ADDENDUM #5

DATED: AUGUST 22, 2025

**PROJECT: Huxford Elementary School Gymnasium
And Classroom Addition For
Escambia County Board Of Education
Huxford, Alabama**

PH&J No: 2312SC

METAL PANEL DETAILS

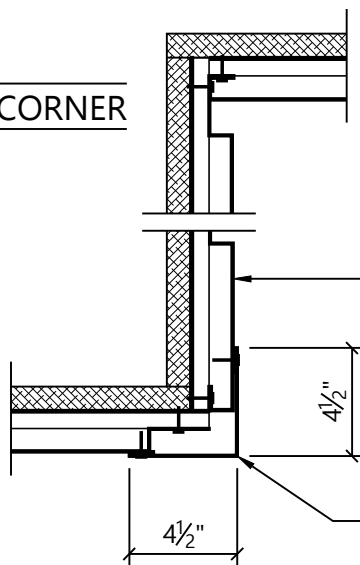
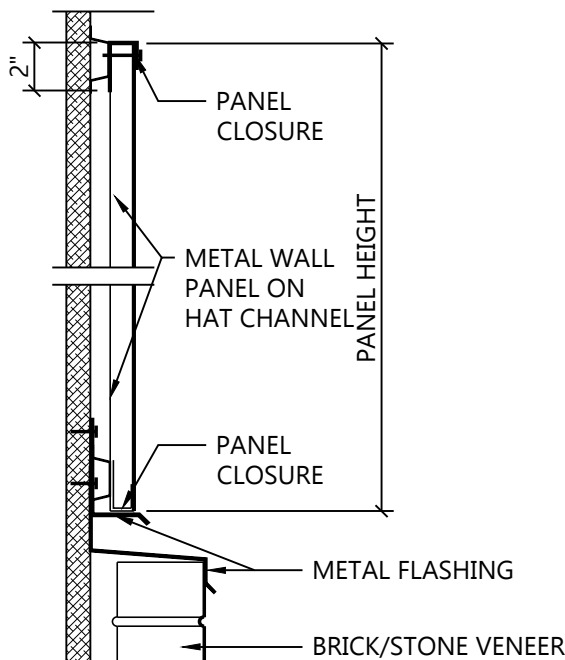
8. **Building Sections (Sections FF & HH/A6.2)**: Modify the note stating “... METAL TRUSSES” to
read “... METAL JOIST”.
9. **Metal Panel Details (Details M/A6.4)**: Add the details to this sheet as contained herein as
Addendum No.: 5; Attachment #1.

BLEACHER WALL SECTION

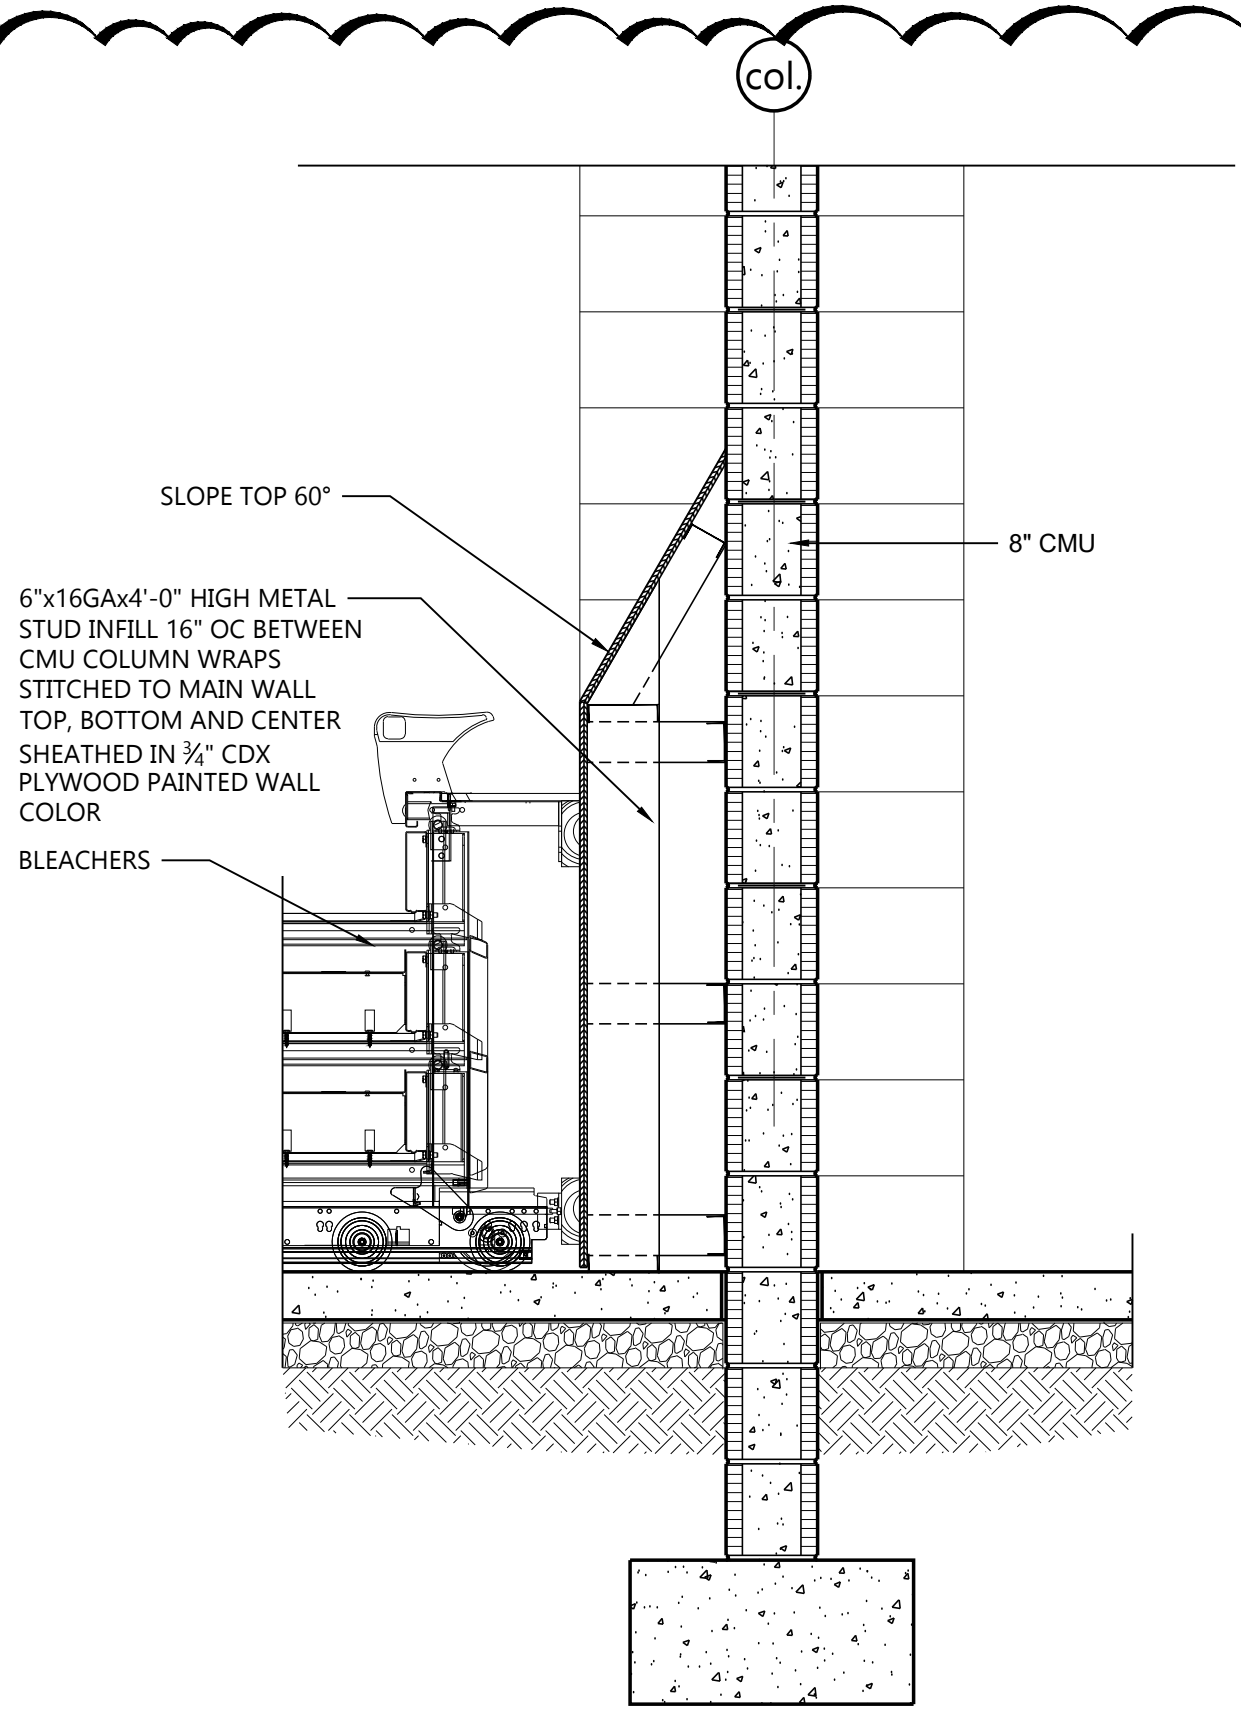
10. **Bleacher/Wall Section (Sheet 2/A6.5)**: Add this section to this sheet as contained herein as
Addendum No.: 5; Attachment #2.
11. **Generator (Sheet E7.3)**: Revise the generator as indicated below:
